Distr.: General
27 July 2010

Economic Commission for Europe**Inland Transport Committee****World Forum for Harmonization of Vehicle Regulations****Working Party on General Safety Provisions****Ninety-ninth session**

Regulation No. 107 (M₂ and M₃ vehicles) – Proposals for further amendments**Proposal for amendments to Regulation No. 107****Note by the secretariat***

Model A

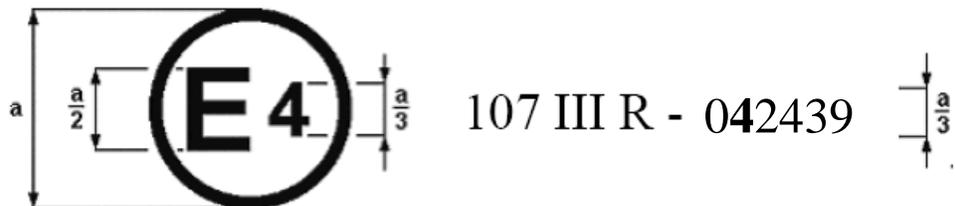
The above approval mark affixed to a vehicle shows that the vehicle type concerned has, with regard to its constructional features, been approved in the Netherlands (E 4) for Class III, pursuant to Regulation No. 107 under approval number 042439. The approval number

indicates that the approval was granted according to the requirements of Regulation No. 107 as amended by the 04 series of amendments.

Model B

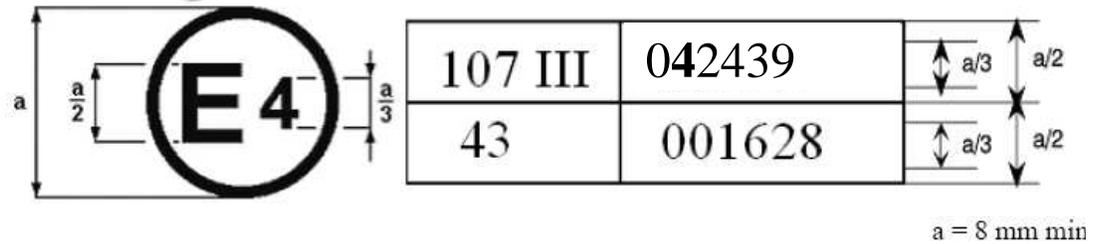
The above approval mark affixed to a vehicle shows that the vehicle type concerned has been approved in the Netherlands (E 4) pursuant to Regulations Nos. 107 and 43.*/ The first two digits of the approval numbers indicate that, on the dates on which these approvals were granted Regulation No. 107 included the 04 series of amendments and Regulation No. 43 was in its original form.
